**DATE:** 06.05.2019  
**TO:** ProTrak  
**FROM:** Mitesh Baxi  
Traffic Engineering

■ **LOFTS AT PARK AVENUE [TRC Plan Review]**

☞ Initial Review Note ☞

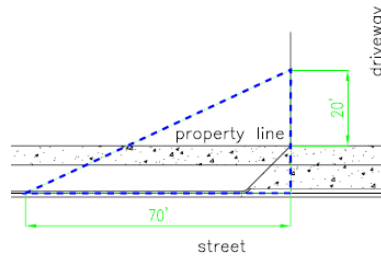
1. Show driveways for adjacent lots and lots across the street.
2. Dimension driveway widths (at the property boundary) and tapers. [Sec.18-530 CofW LDC]
3. The minimum two-lane driveway width is 23'. [7-9 CofW Tech Stds]
4. Driveways are to intersect the street at a 90 degree angle or a variance may be required. [7-11 #3 CofW Tech Stds]
5. City's 20'x70' sight distance triangle must be implemented as per below image. [Sec.18-529(c) (3) CofW LDC] [Sec. 18-812 CofW LDC].
